LODHA PALAVA

Florea and Olivia Podium Retail Landscape

Option 3

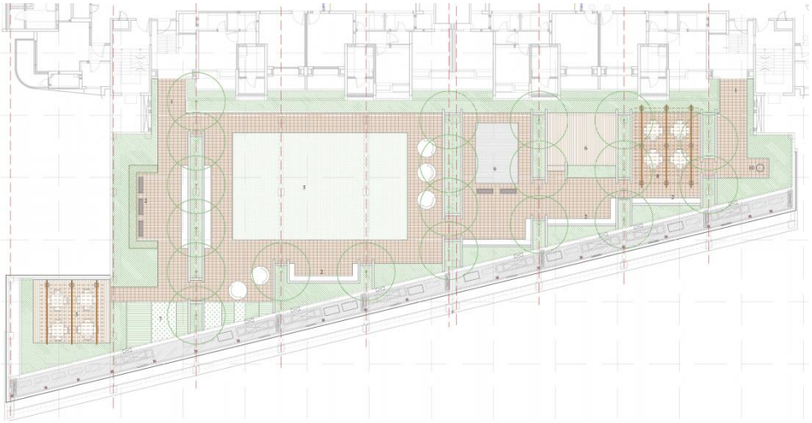
1. Requirement of a larger congregation lawn
2. Proposed trees need to be on the columns only and not on the column beam grid.
3. Group Activities should be proposed away from the apartments to avoid disturbance.
4. No vertical element like trellis / walls in front of the apartment windows .
5. Trellis deck with seating to be moved away from the parapet wall
6. No vertical elements in the 2mts sunk (service corridor)

- Large lawn size - Option 3 preferred
- Variety in seating arrangements and type - Option 1 preferred
- Semi covered spill out space for the congregation lawn - Option 1 preferred

Overall Option 1 is preferred with the lawn size as in option 3.

Olivia Option 1

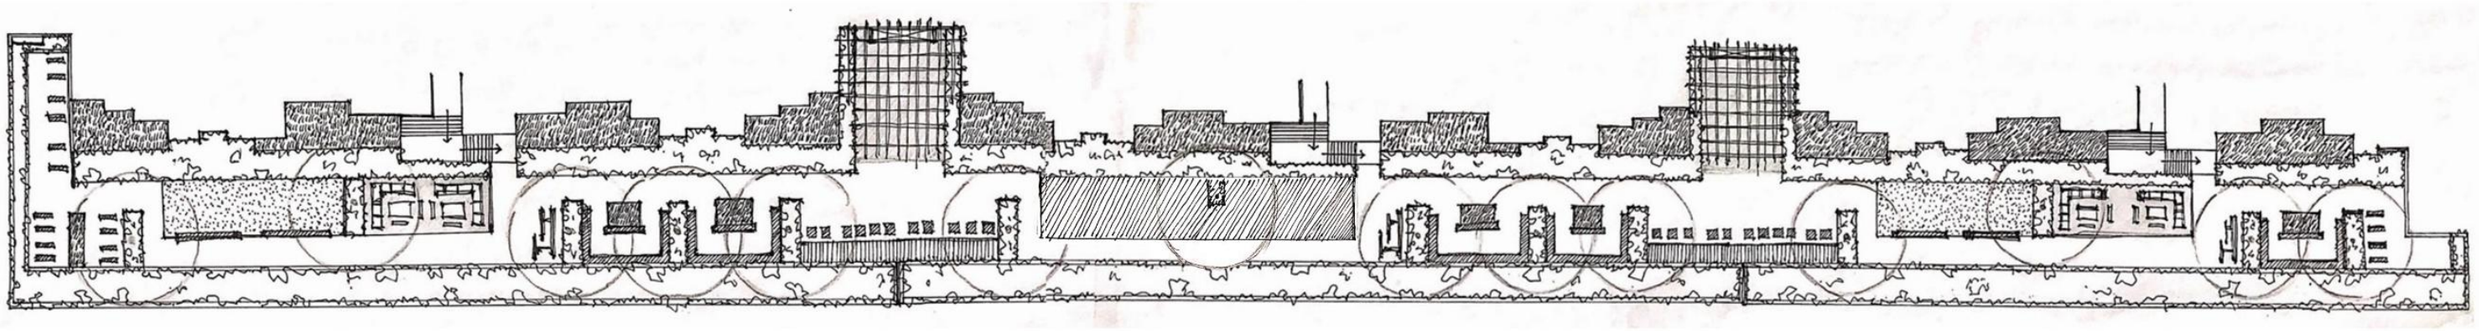
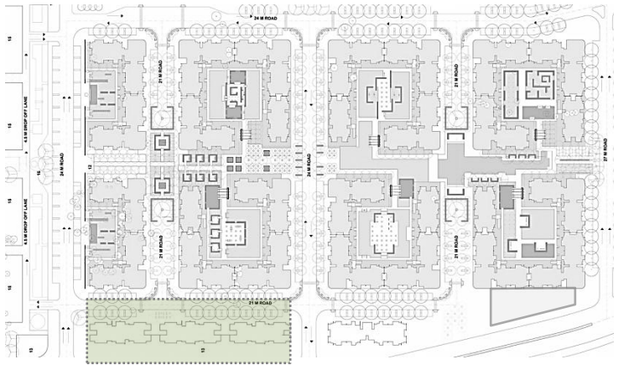
1. Larger congregation lawn needed
2. Trees need to be as per structural guidance.
3. Seating preferred in niches / corners between buildings.
4. Walkway /circulation path needs to be away from the units.
5. Minimize the hardscape area.
6. Designated area for games – floor games / outdoor gym.
7. No planting on the service shaft

Olivia_Option 1 and 2

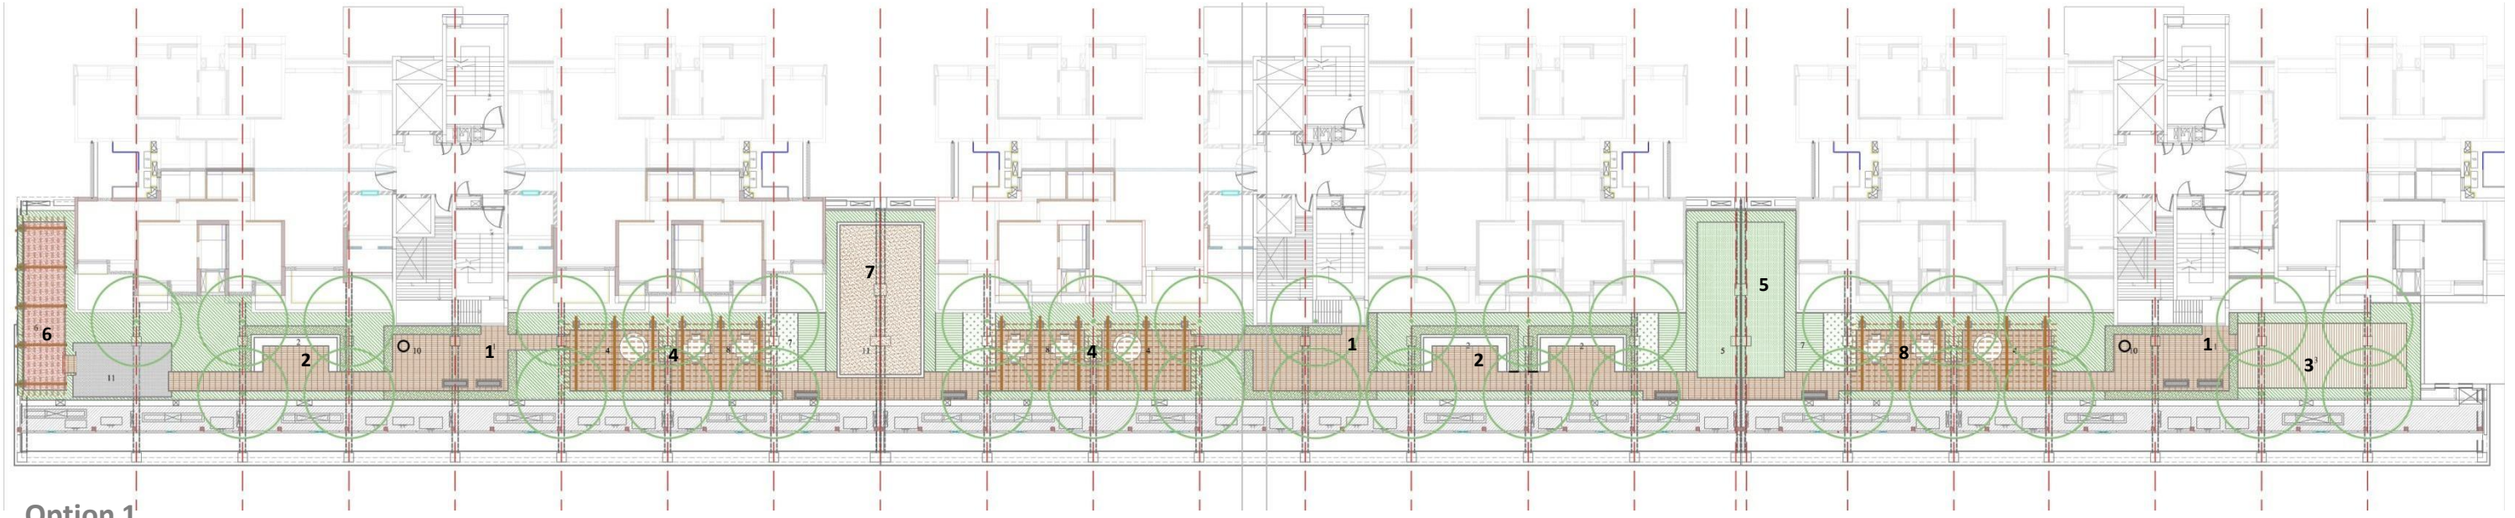
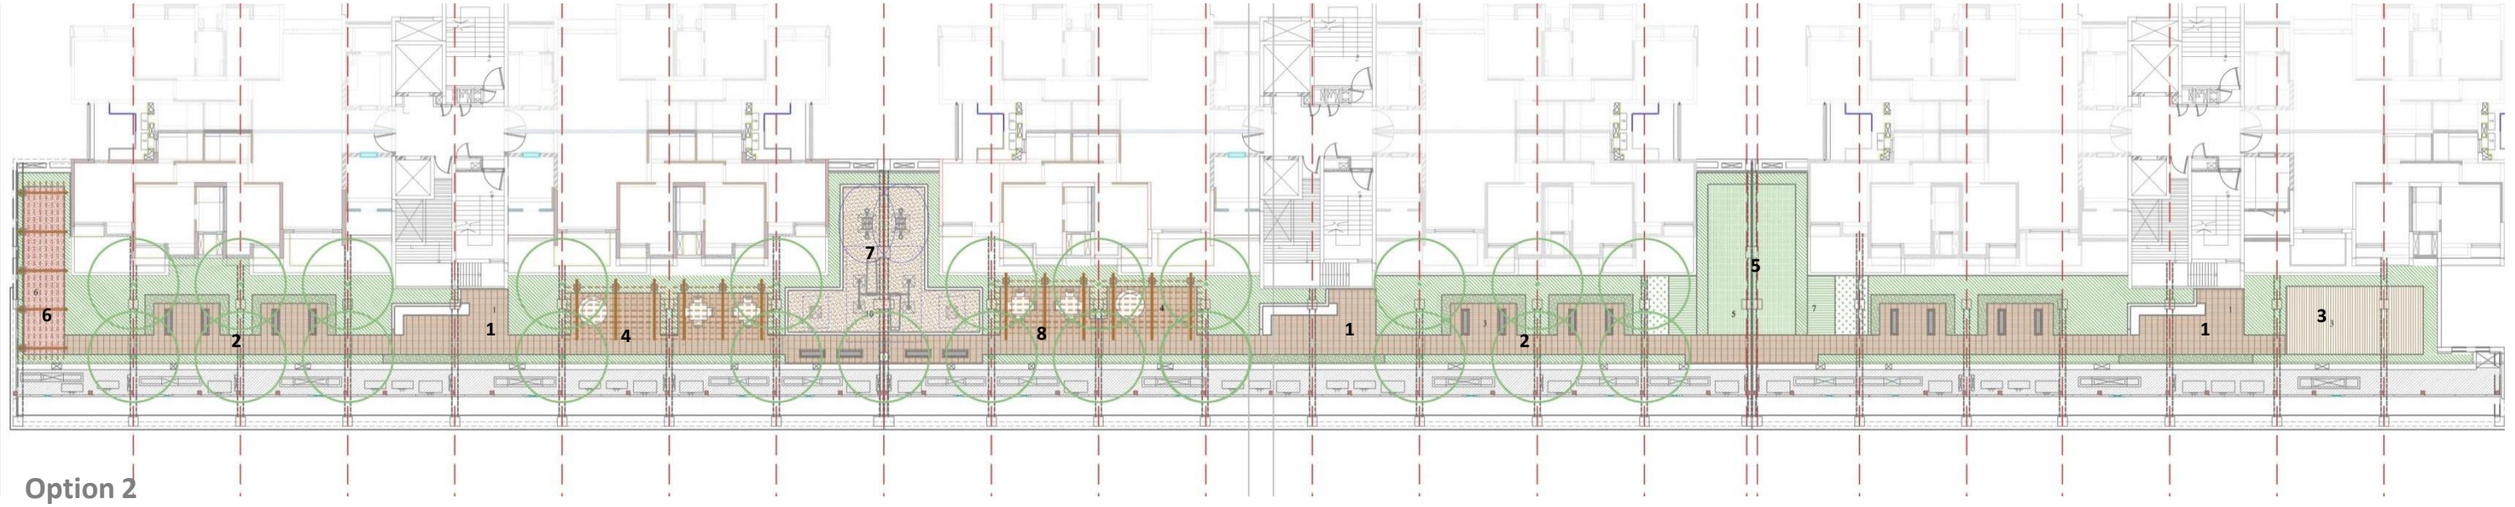
1. Proposed trees need to be on the columns only and not beams.
2. Activities proposed should be away from the apartments to avoid disturbance.
3. No vertical element in front of the apartment windows.

Option 1

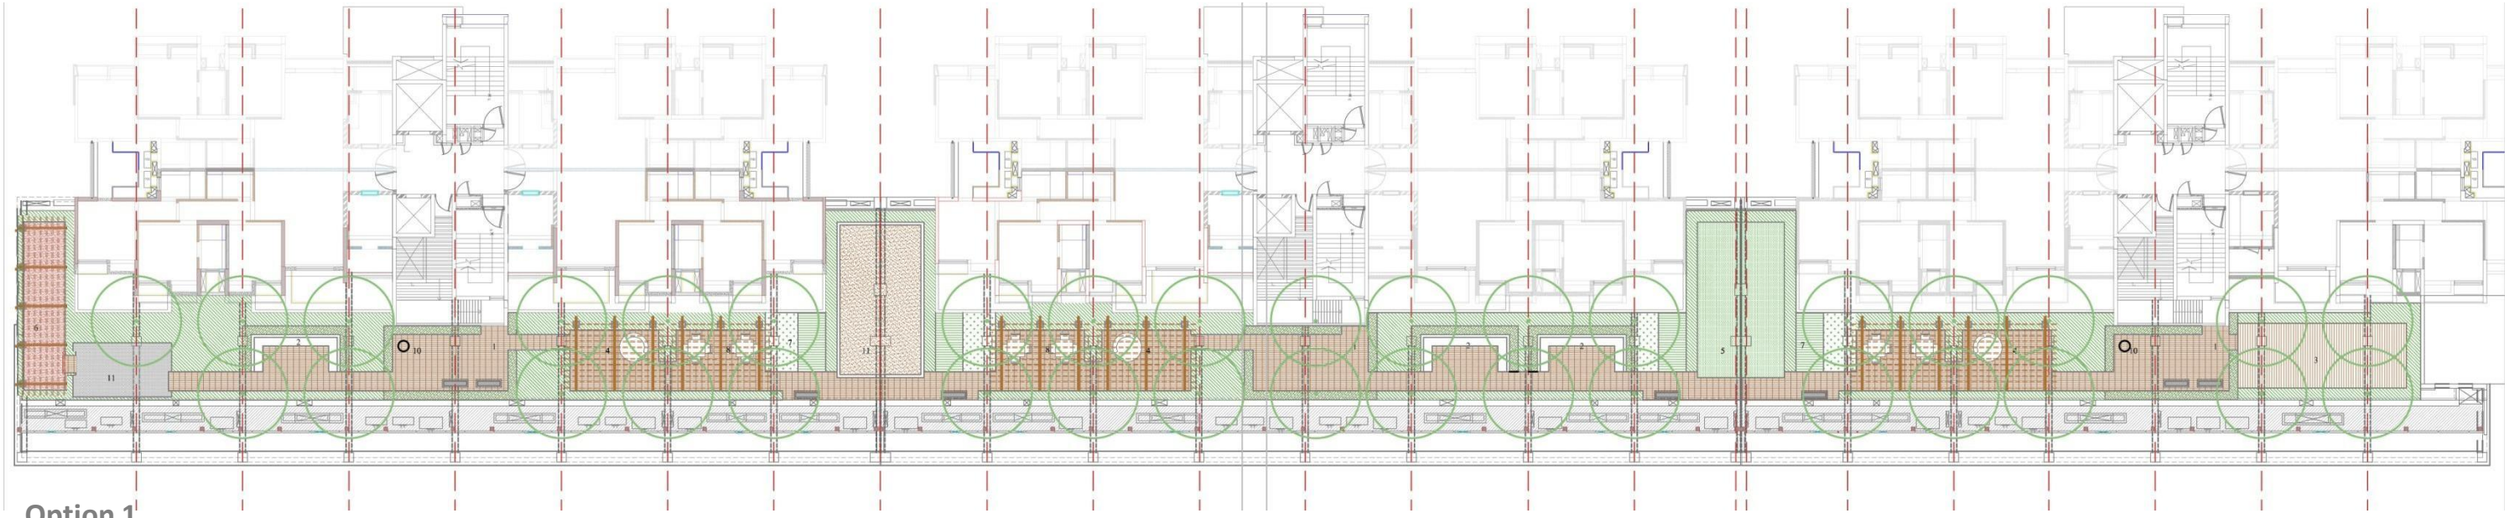
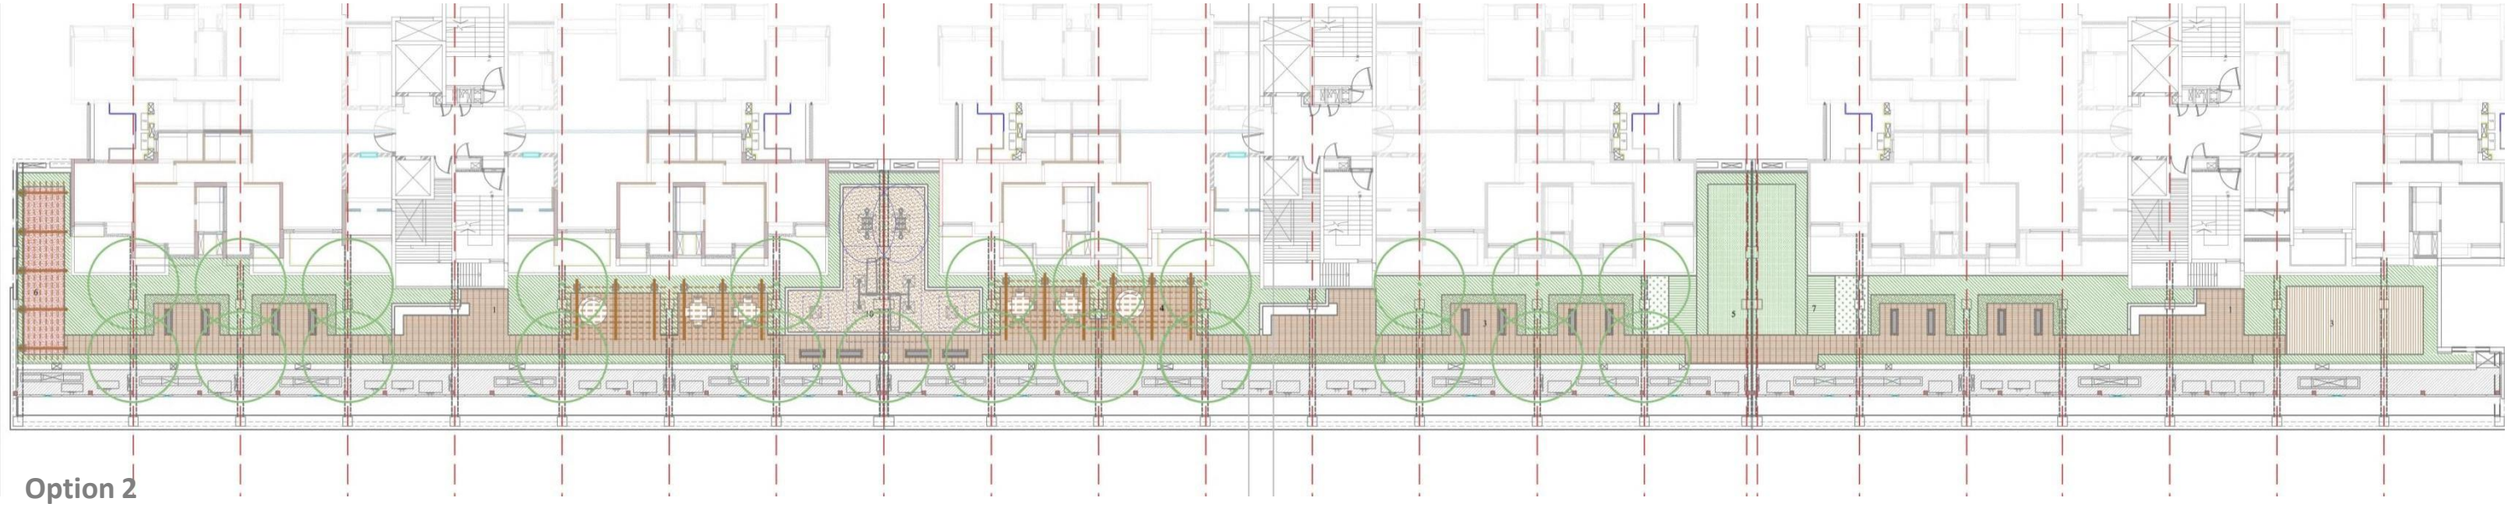
1. Proposed trees need to be on the columns only and not beams.
2. Activities proposed should be away from the apartments to avoid disturbance.
3. No vertical element in front of the apartment windows.
